# Proposal concerning signs and signals on European waterways covered by CEVNI

Transmitted by a Canadian citizen

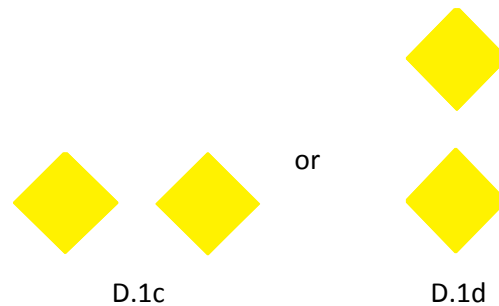
It is proposed to consider the replacement of the sign D.1c / D.1d:

- D.1 Recommended opening
- (b) Only in the direction indicated  
(passage in the opposite direction prohibited)

with the following sign, possibly with a single black-arrow indicating the direction of travel :

To avoid possible confusion and make navigation simpler, with less chance of an error, on European waterways.

A solid-green diamond-shaped sign (with a directional arrow if it is believed necessary) would be a good replacement for the current use of two yellow diamond-shaped signs to indicate one-way passage under a bridge or arch. A green sign would be of substantial benefit on long bridges with multiple arches. There are some now that have a channel under one arch marked by a single yellow-diamond - and another channel marked with two yellow-diamond signs. Being of a contrasting colour to the yellow on the two-way passage sign, a green sign would allow users of the waterways to differentiate between the two-way channel and the one-way channel at a greater distance - especially when visibility is reduced.

For one-way traffic, two yellow-diamond signs are confusing - and the colour yellow is not necessary as there should not be any likelihood of oncoming traffic. The diamond shape would be familiar to those who have already traveled under bridges on the waterways. The green colour would indicate that the route is relatively safe (as compared to a two-way-traffic channel).

For those who say that a green sign would conflict with the green signage indicating the left-bank side of a channel, the author would argue that there would be no confusion. This is partly because of the shape of the sign (There is no solid-green diamond-shaped sign in CEVNI at the moment) but mainly because of the location of the sign. These signs would only be used on bridges and arches.

During a transition period, both the green-diamond sign and the two yellow-diamond signs appear together on bridges and arches. After a period of time, users of European waterways would realize that the green-diamond sign has the same meaning as the two yellow-diamond signs and the latter could be removed without any compromise to safety on the waterways.
